SUBJECT: **Safety Recall 05S28 - Supplement #14:** 1992-2004 Multiple Vehicle Lines - Speed Control System Modification

REF: Safety Recall Bulletin 05S28 Supplement #13 dated September 5, 2007

New! REASONS FOR THIS SUPPLEMENT

FIGURE 1

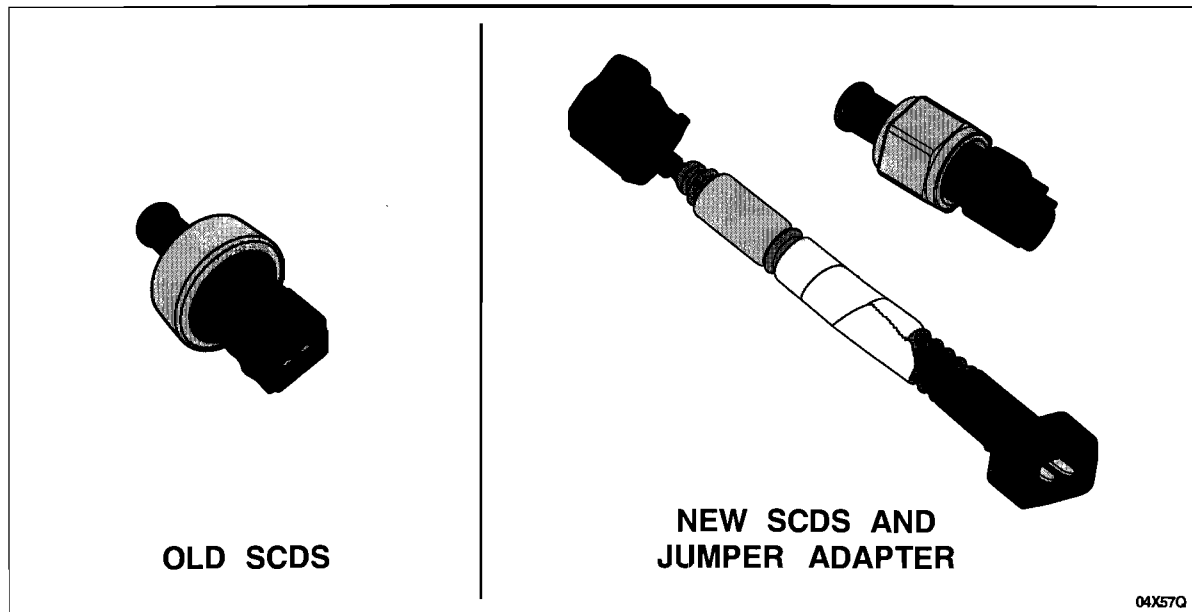
The Speed Control Deactivation Switch (SCDS) involved in Recall 05S28 and the revised SCDS is illustrated below. See Figure 1.

Note that the revised SCDS has a different electrical connector. A jumper adapter (which is included in the parts kit) is required when replacing the old SCDS with the revised SCDS.
